AMENDMENT 5

**Invitation for Bid (IFB)
UOG IFB No. B23-01**

QUESTION & ANSWER SHEET NO. 3
July 25, 2023

UOG IFB B23-01: INVITATION FOR MULTI-STEP SEALED BIDS FOR CONSTRUCTION SERVICES

DWG NO:
2ES101

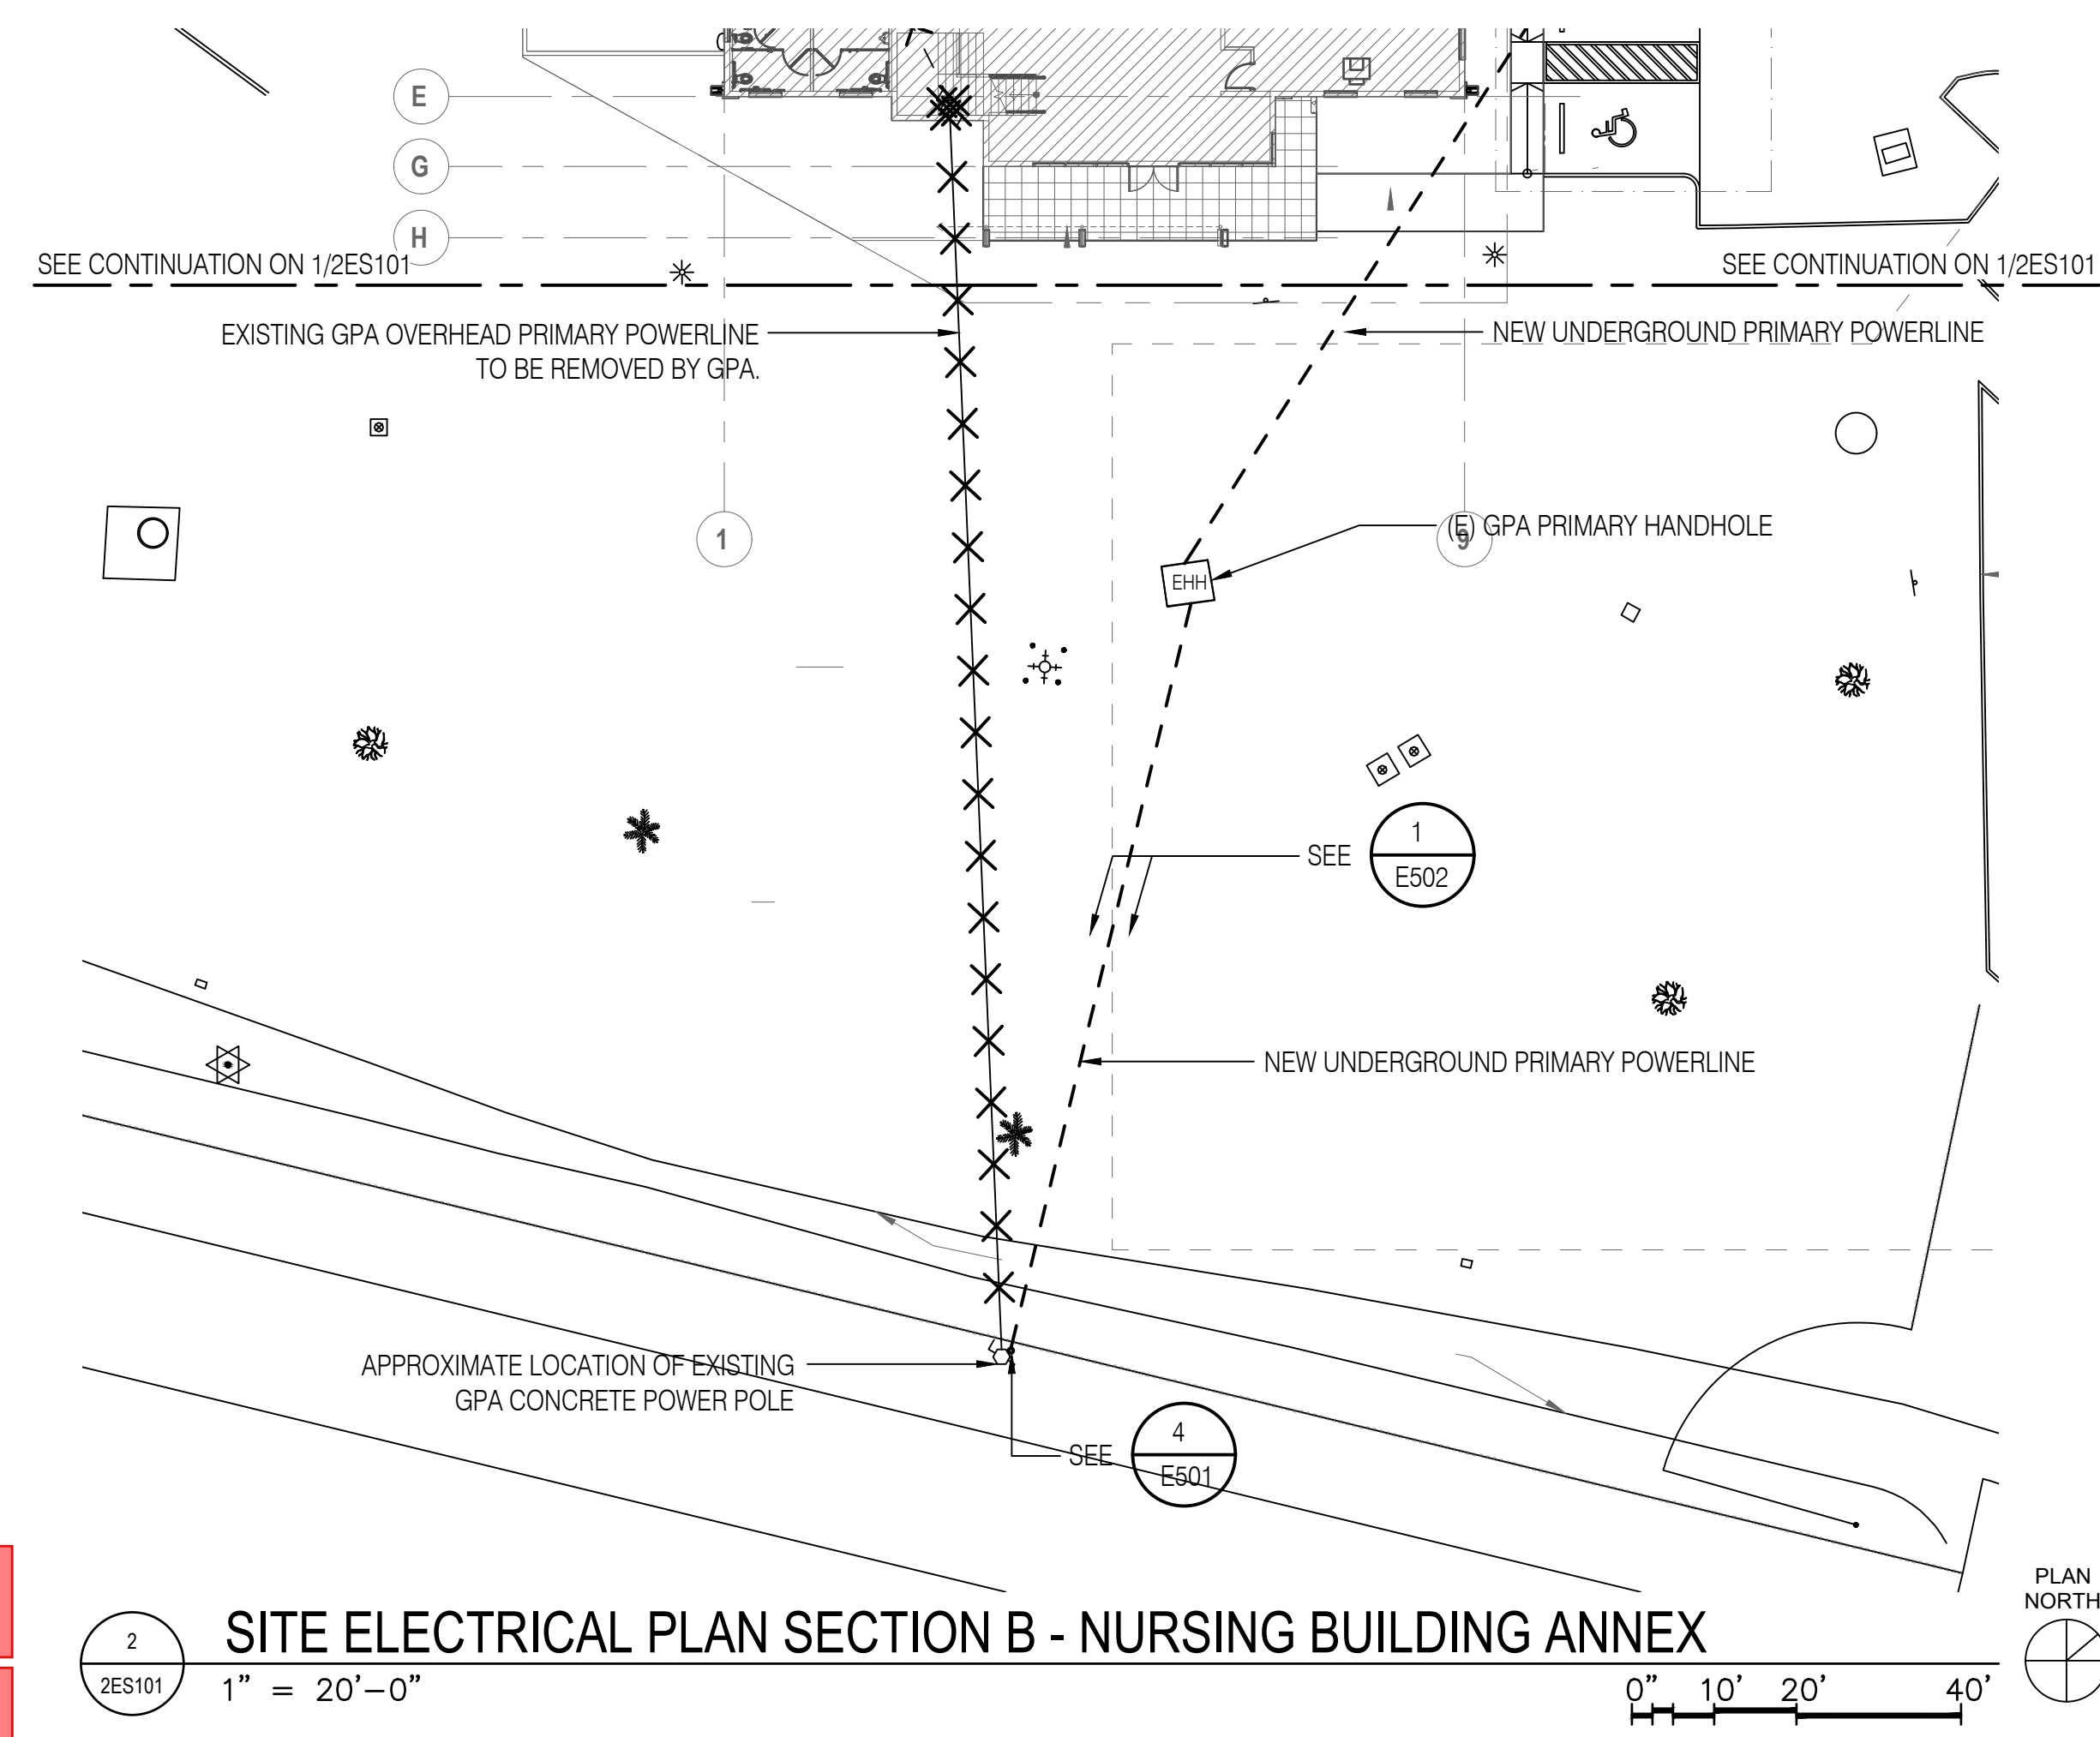
Please provide specs for the Fiber Optic Cable.
 Kindly provide Pull Box size

Confirm if this will be provided by the GC and specify its dimension / specifications if not.

Please confirm if this will be provided by GC. Kindly provide the dimension / specifications if not.

2EP101

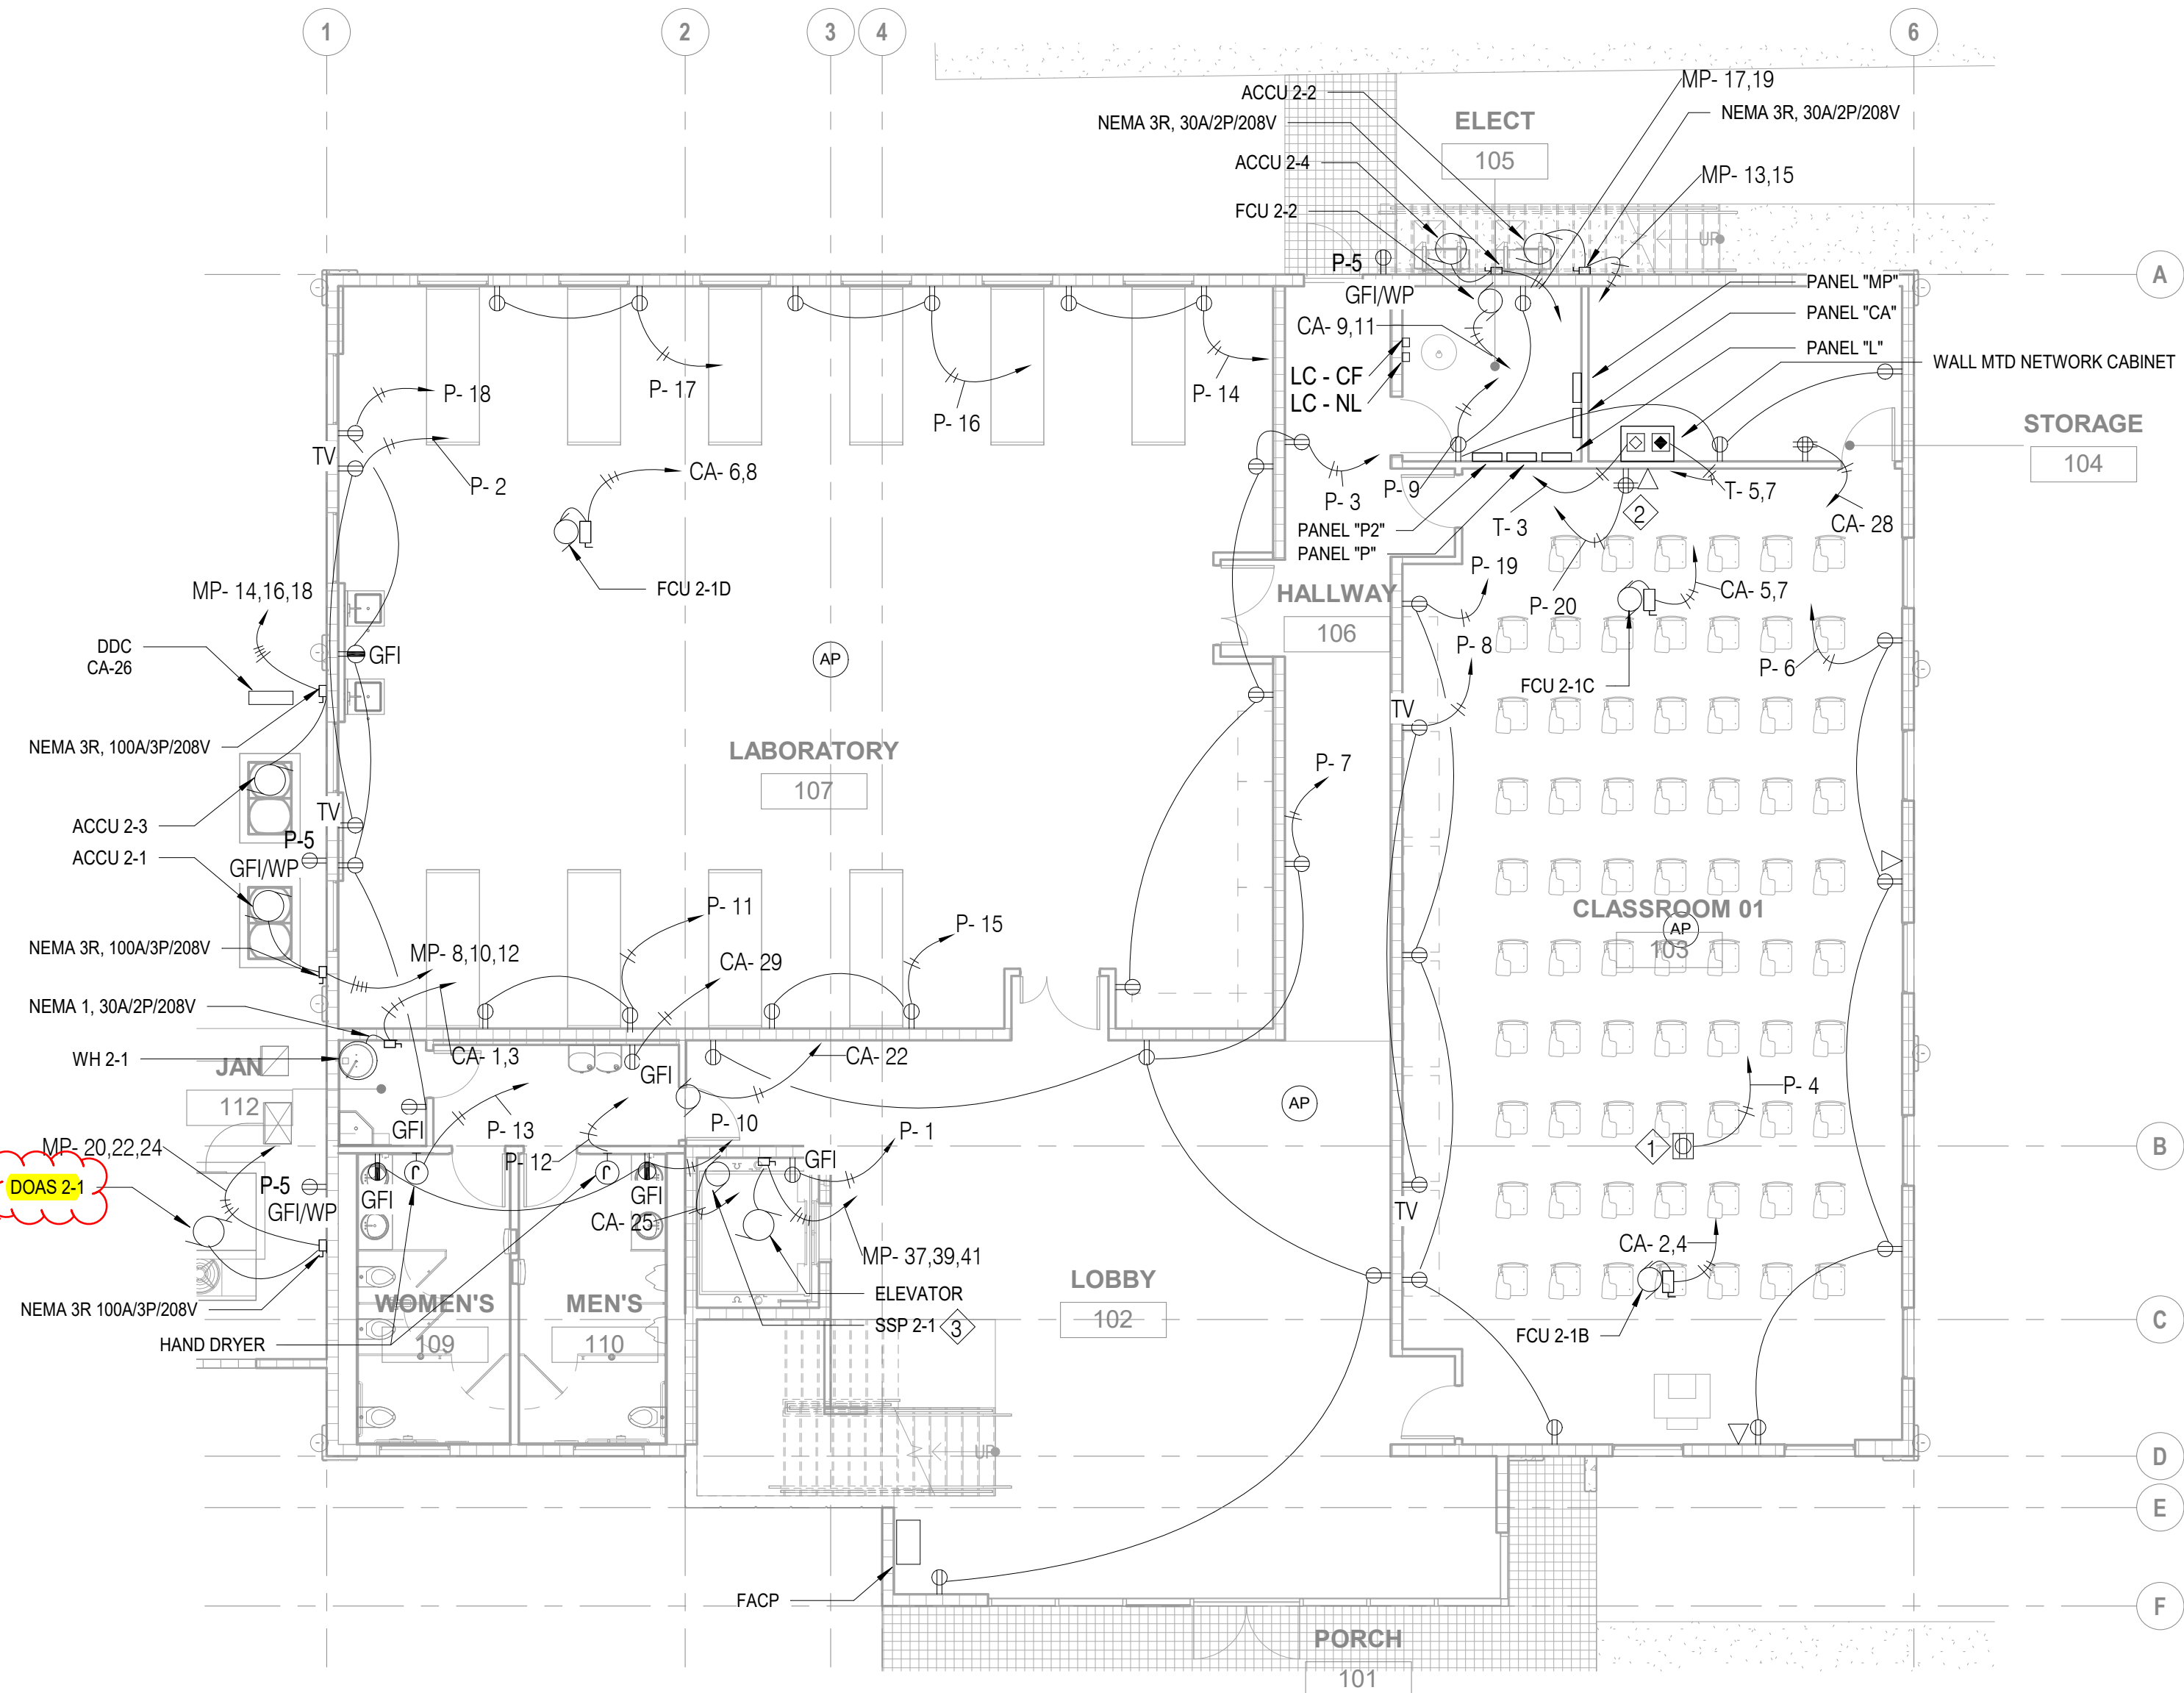
Confirm if this is DOAS 2-3 as indicated on the Schedule of Loads for Panel "MP"
